DRAFT

**Specific Site Assessment for
Coal Combustion Waste
Impoundments at Duke Energy
Carolinas Lee Steam Station**

Williamston, South Carolina

LEE STEAM STATION - ASH BASIN
Secondary Dike @ STA 20+80

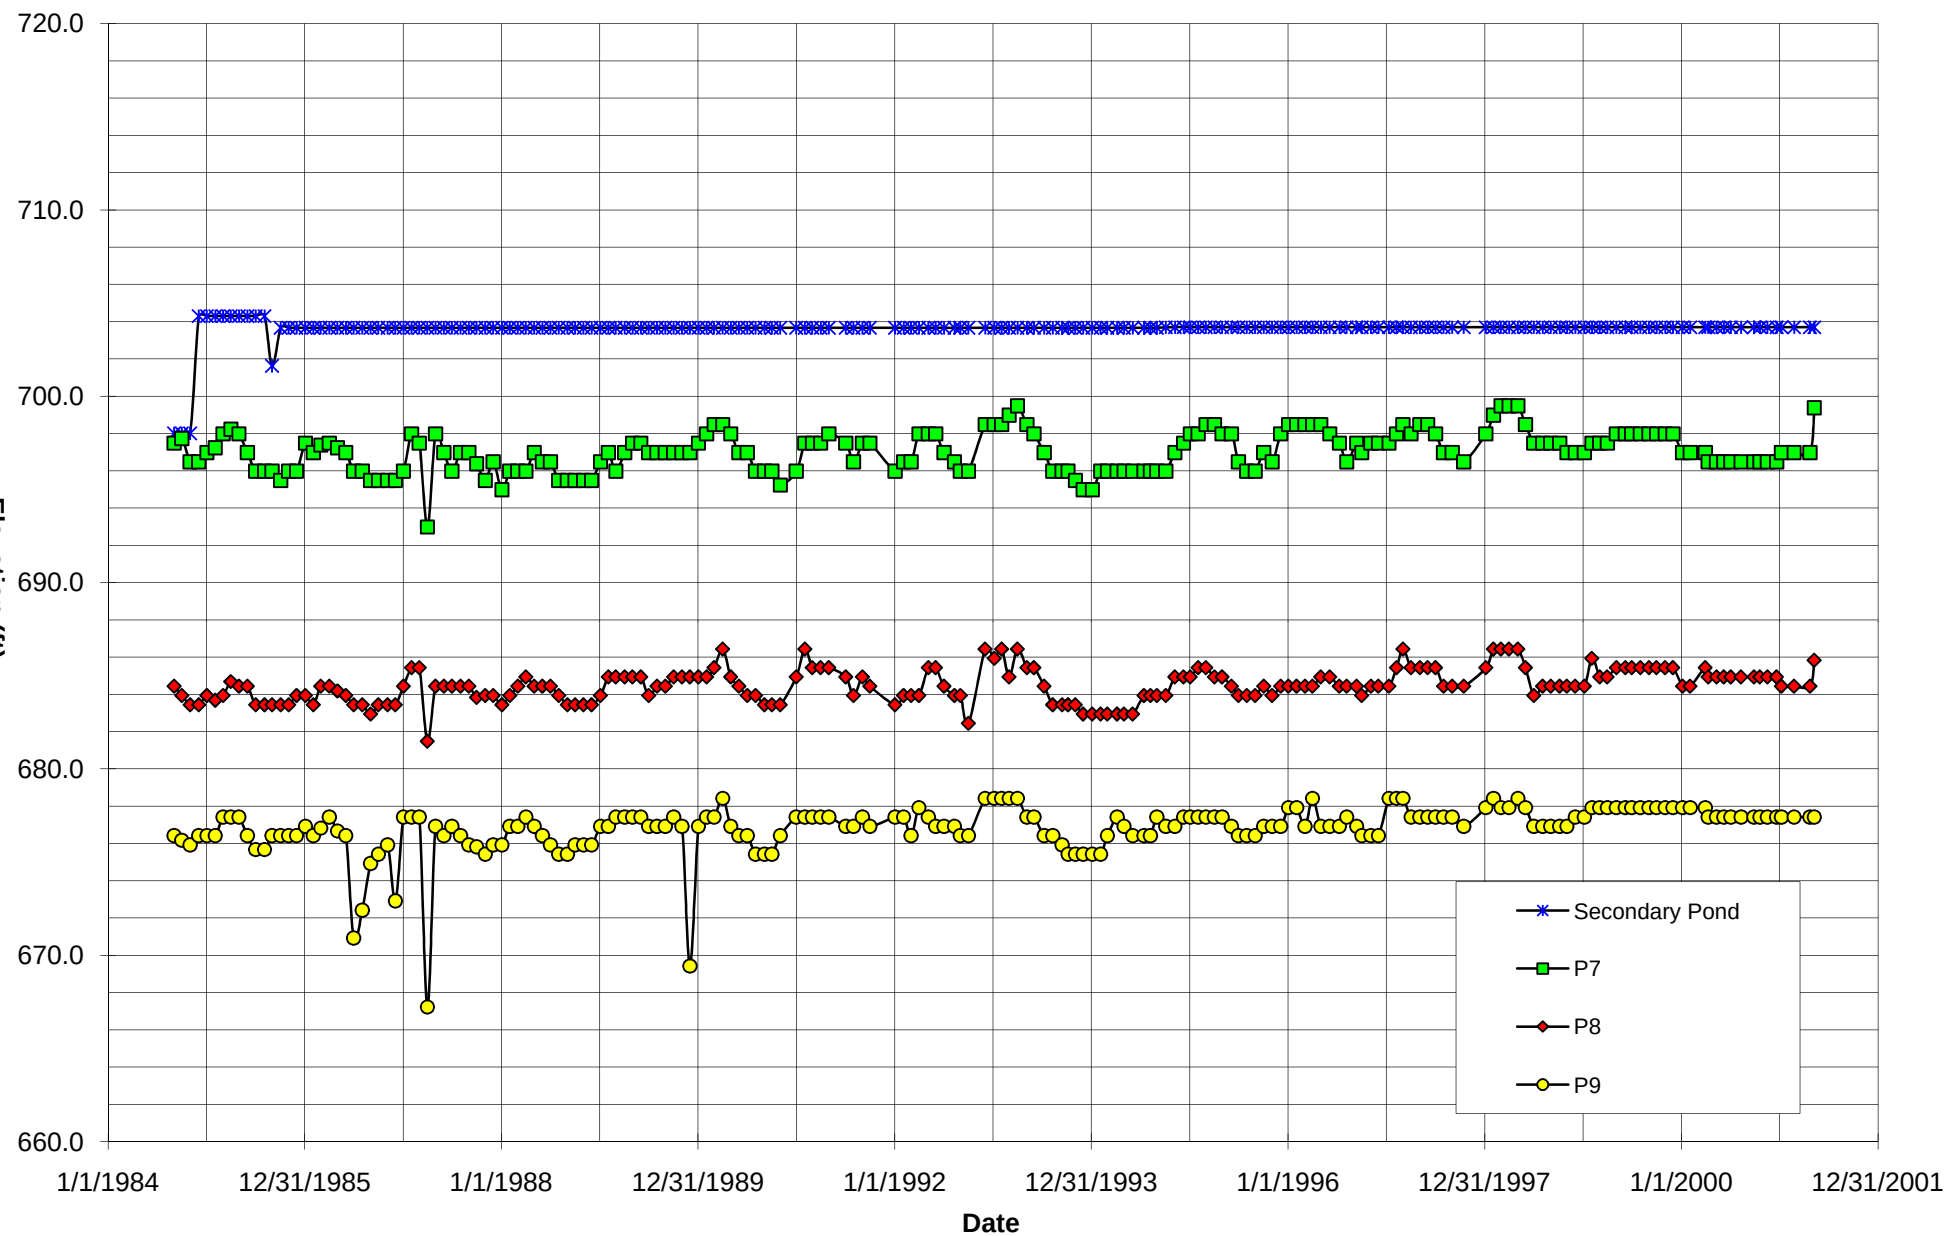
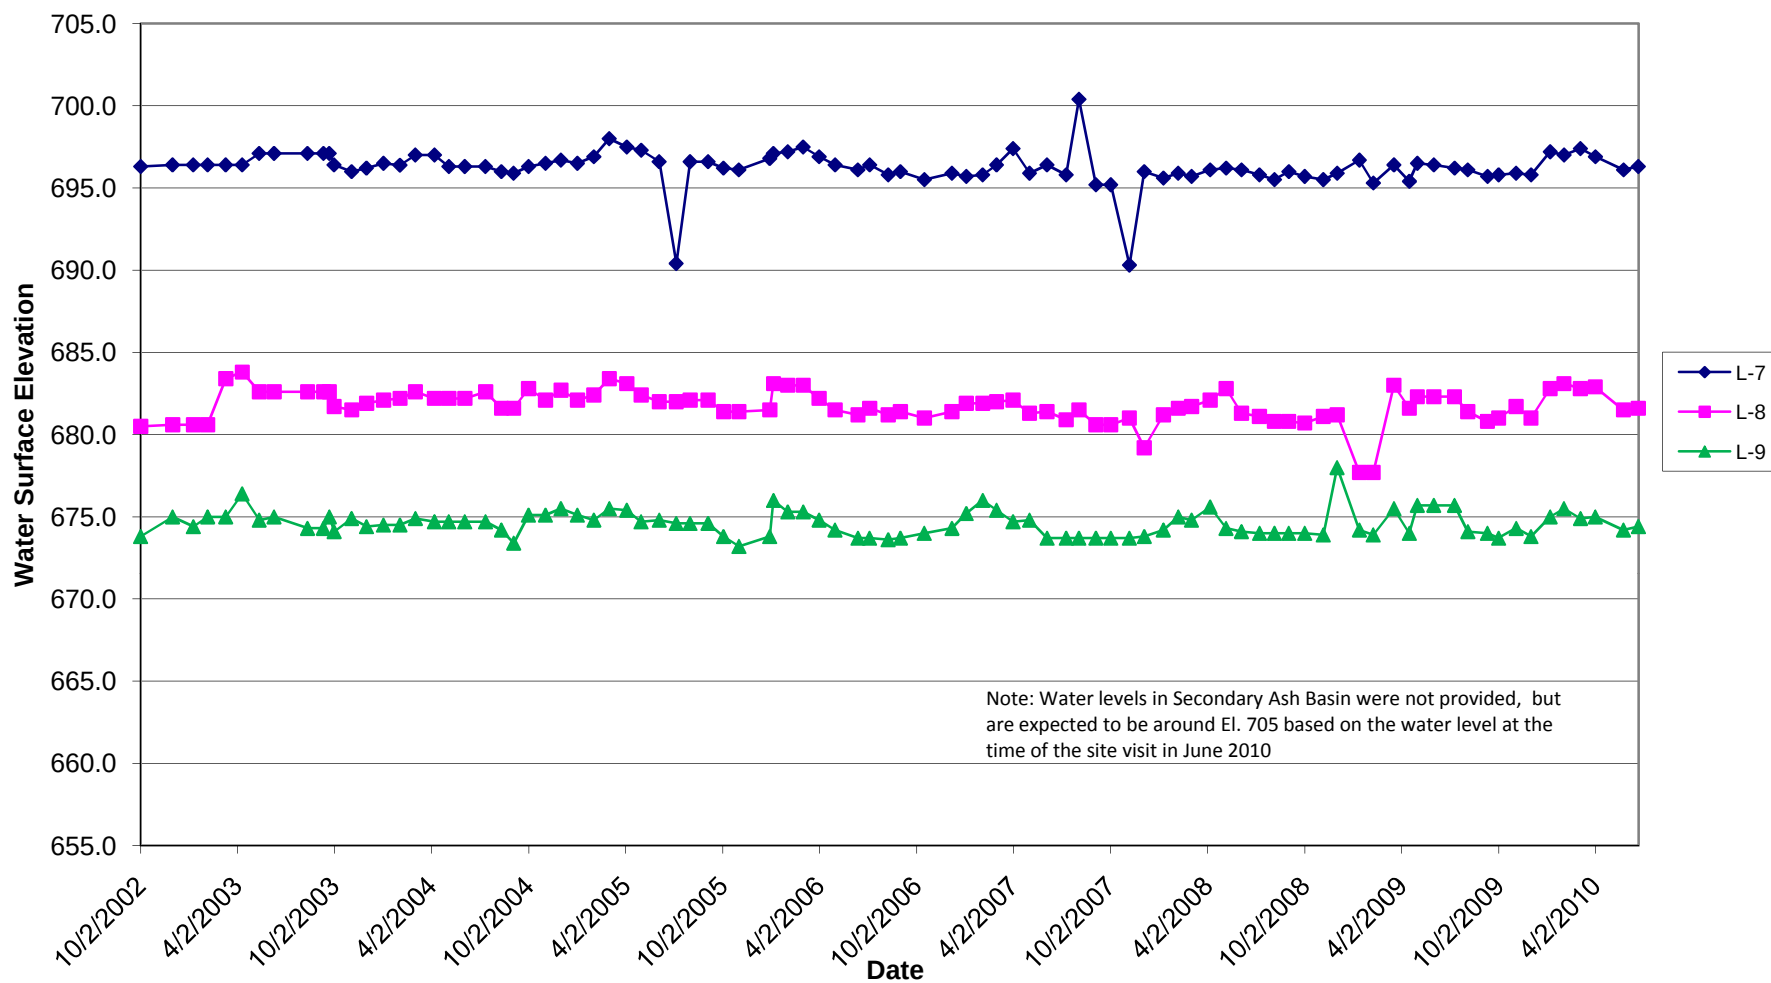
The water levels in piezometers L-7, L-8 and L-9, near the center of the Secondary Ash Basin dam, have remained relatively steady with time. These piezometers generally have fluctuated more than those in the other two cross sections. Typically the water levels in the piezometers fluctuate in parallel with one another and stay within about five feet of an average value with no steady increasing or decreasing trend. The water levels in L-7 and L-8 are similar to the water levels in the corresponding piezometers near the crest and mid-slope of the Primary Active Ash Pond dam. The water level in Piezometer L-9, however, is about ten feet higher than the water levels in the other two piezometers near the dam toe (El. 675 vs. El. 665). The toe drain at this location is located around El. 665 according to design drawings. This elevated water level may indicate that the toe drain is not functioning properly at this location. Piezometer L-9 is also located just west of the seepage area downstream of the right abutment of the Secondary Ash Basin dam, and the elevated water level may be related to the seepage observed at that location.

The instrumentation installed at the Lee Steam Station CCW impoundments is functioning properly, and the frequency of readings is considered adequate. High water levels have been measured in Piezometers L-4 (between August 2009 and April 2010) and L-9 (compared with the other piezometers near the dam toe). The cause of these readings should be investigated.
